**BEFORE THE BOARD OF PATENT APPEALS
AND INTERFERENCES**

Application Number: 09/652,927
Filing Date: August 31, 2000
Appellant(s): MEYERS, THEODORE W.

EXAMINER'S ANSWER

Attachment #1

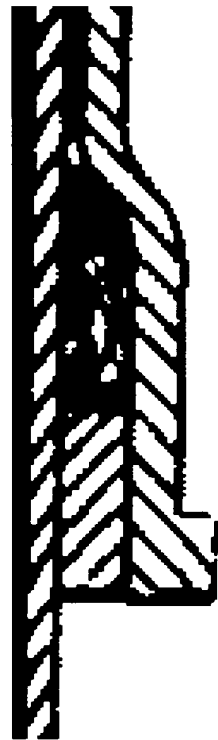
The applicant is invited to check attachments #1 and #2. As seen in attachment #1, Morrison illustrates the inlet/outlet port. In attachment #2, Morrison illustrates that the inlet port is capable of receiving a pipe with a first and second outer diameters. By

inlet/outlet port receiving a pipe
with a first outer diameter

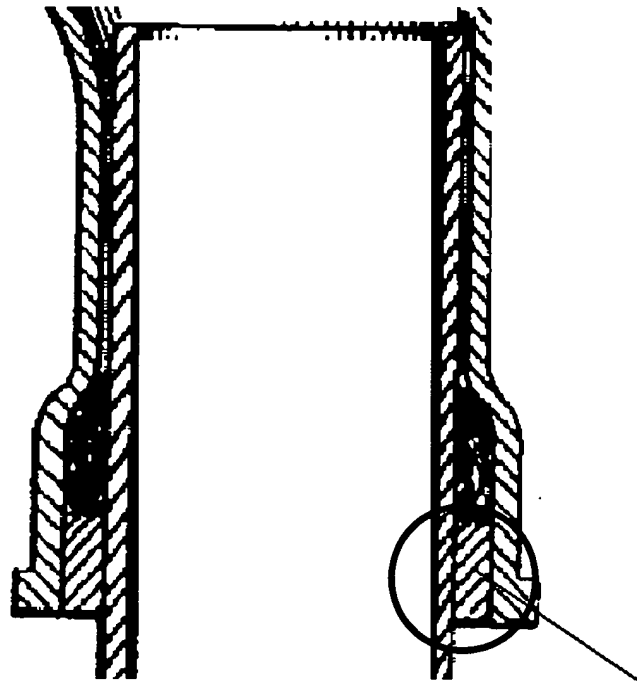
using a reducer, Morrison inlet/outlet port is capable of receiving different diameters of pipes.

reducer

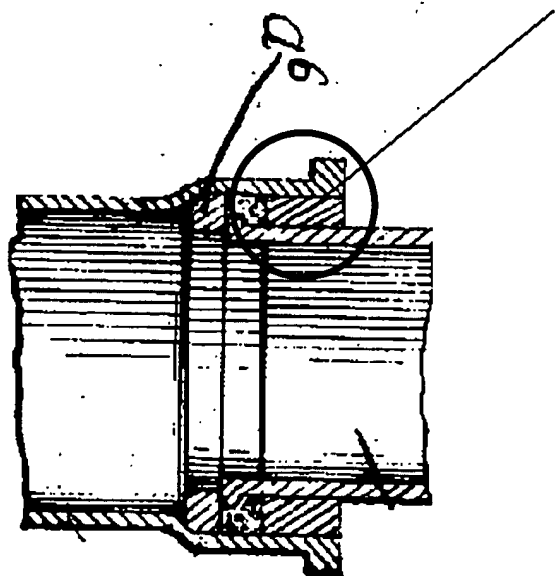
The applicant also argues that Morrison fails to disclose a reducer so as to suggest that Morrison is capable of receiving different diameters of pipes. The applicant cited that Morrison discloses a ring (a6) and that there is no teaching of a pipe received inwardly of the ring (Page 16 Line 3 and Page 17 Line 4).

The applicant is invited to check attachment #3. The examiner acknowledges that element a6 is a ring, however, the reducer is not element a6. As seen in the attachment, Morrison illustrates a reducer that allows a user to use a pipe having a smaller outer diameter. Therefore, Morrison clearly illustrates the use of a reducer.

Attachment #4

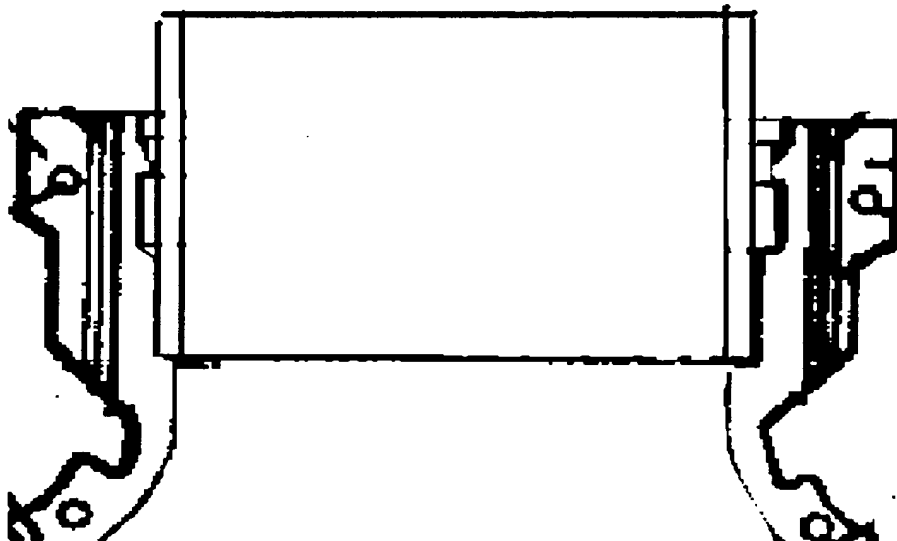
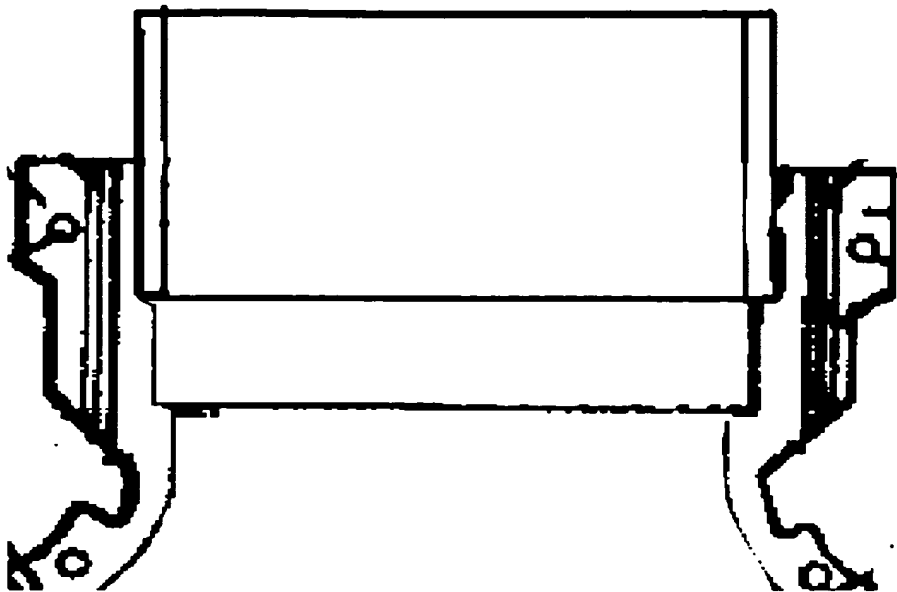
The applicant argues that Ramm fails to disclose that the inlet/outlet port having a diameter sized so as to receive a pipe of a first outer diameter and being adaptable to receive a pipe of a second outer diameter (Page 17 Line 18).

The applicant is invited to check attachments #4 and #5. As seen in the attachments, Ramm illustrates that the inlet/outlet port is capable of receiving a pipe with a first and second outer diameters. By providing pipe seat having different diameter, Ramm device is capable of receiving different pipe sizes.

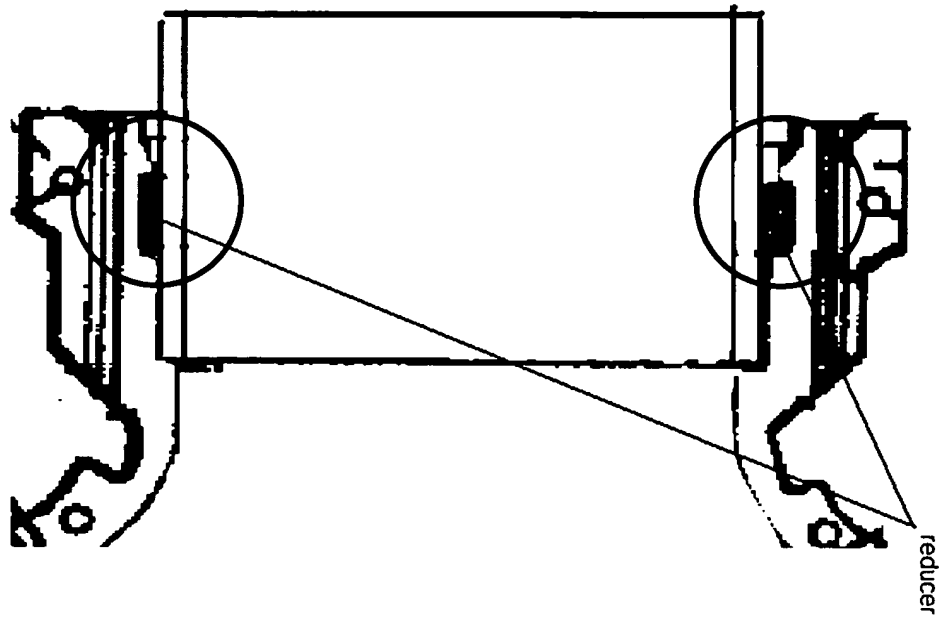
As seen in attachment #5, Ramm device is capable of receiving a pipe with a first and second outer diameters because of the steps presented in the port. Morrison illustrates the use of a reducer in a pipe coupling (see attachment #3). It would be obvious to one of ordinary skill in the art to provide Ramm's device with a reducer in order to adapt different pipes with different outer diameters, as seen in attachment #6.
